ARIZONA DEPARTMENT OF ENVIRONMENTAL QUALITY

March 12, 2008

Re: Mitigation Order on Consent, Docket No: P-121-07- Work Plan

Attachment #1

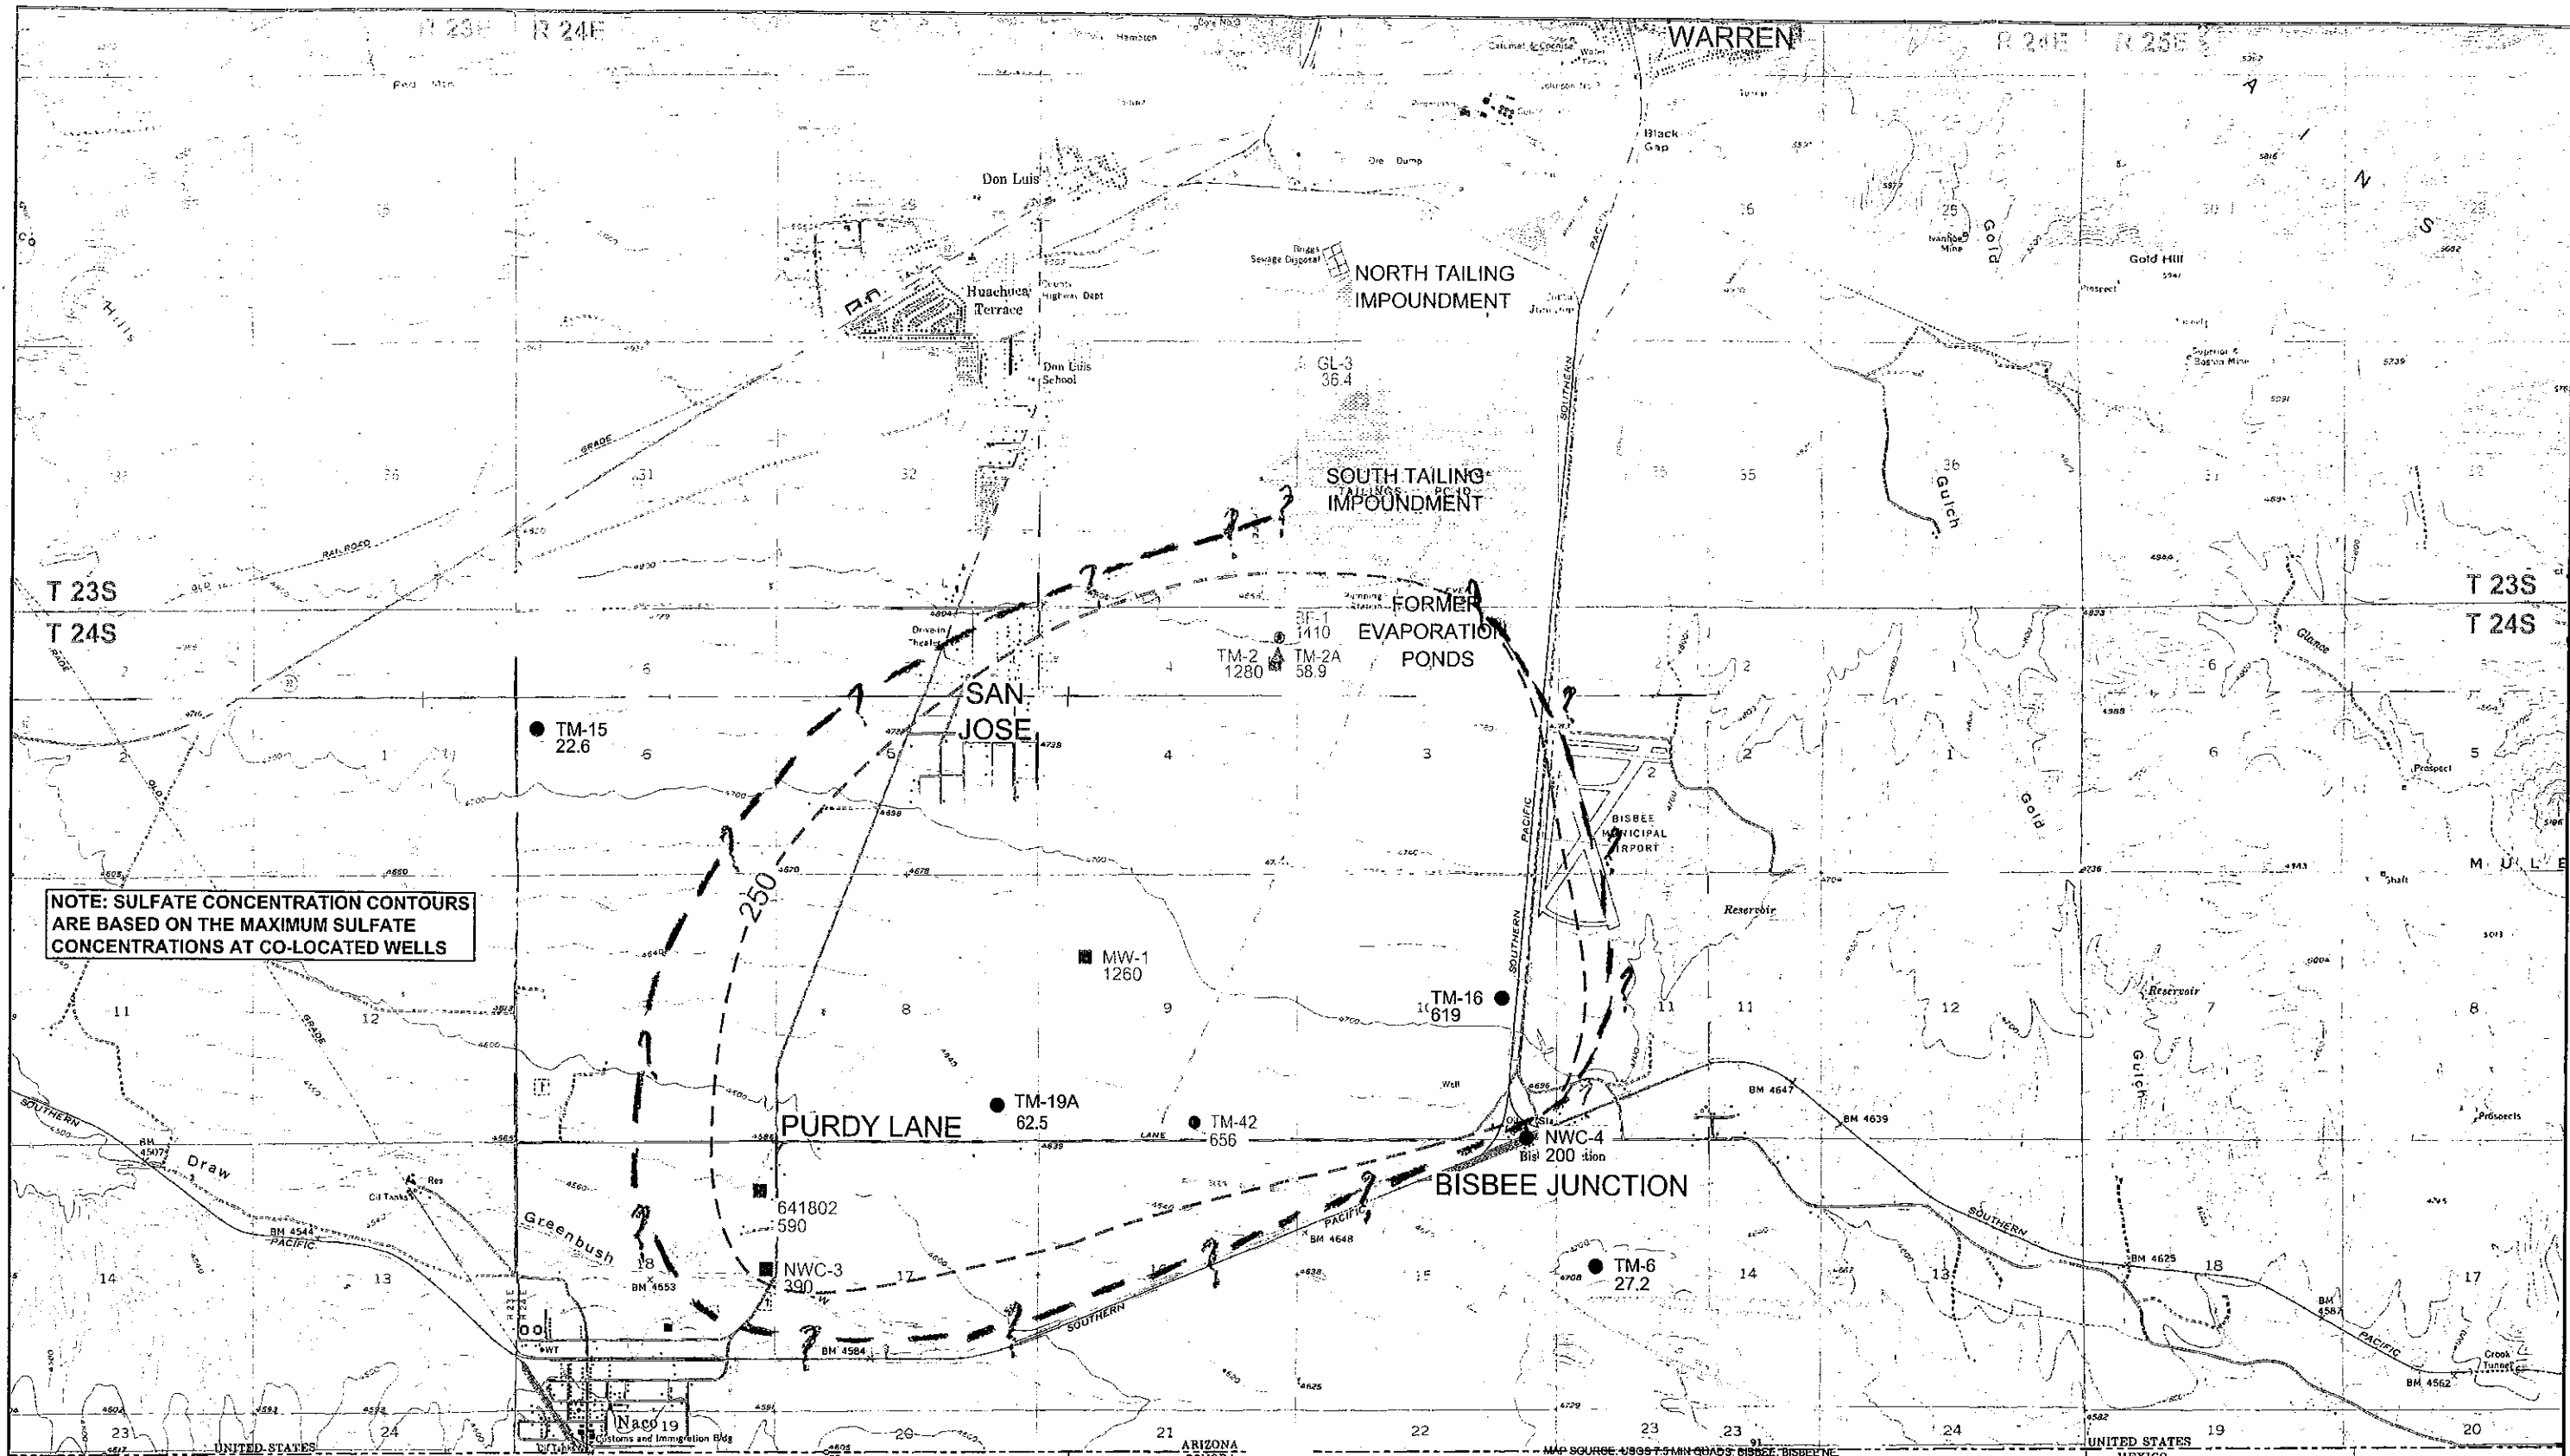
- a. This section provides an estimation of the current extent of the sulfate plume based upon limited 2005 groundwater sampling and inferences from the 1996 groundwater sampling. It estimates the sulfate plume as being "approximately 3.5 miles long in a southwesterly direction and 2.5 miles wide, with its northern boundary located at the southern margin of the South Tailing Impoundment and its southern edge south of Naco Water Company (NWC) well 3 (NWC-3) (Figure 4)." Based upon data presented in Figure 4 "Sulfate Plume, 2005 Approximate Boundary of 250 mg/L Sulfate Concentration, Bisbee, Arizona," Attachment #1, ADEQ believes that the sulfate plume is probably slightly longer than depicted. Well NWC-3 had a sulfate concentration of 390 mg/L, while the work plan shows the 250 mg/L contour as being right next to the well. The contour should be at some distance beyond well NWC-3. See Attachment #1 for ADEQ's reconfiguration of the maximum extent of sulfate contamination. This is based upon the limited data collected and reviewing data presented in Figure 14, "Sulfate Concentration Map – July 1989," and Figure 15, "Sulfate Concentration Map – Summer 1996," Attachments #2 and #3, respectively.
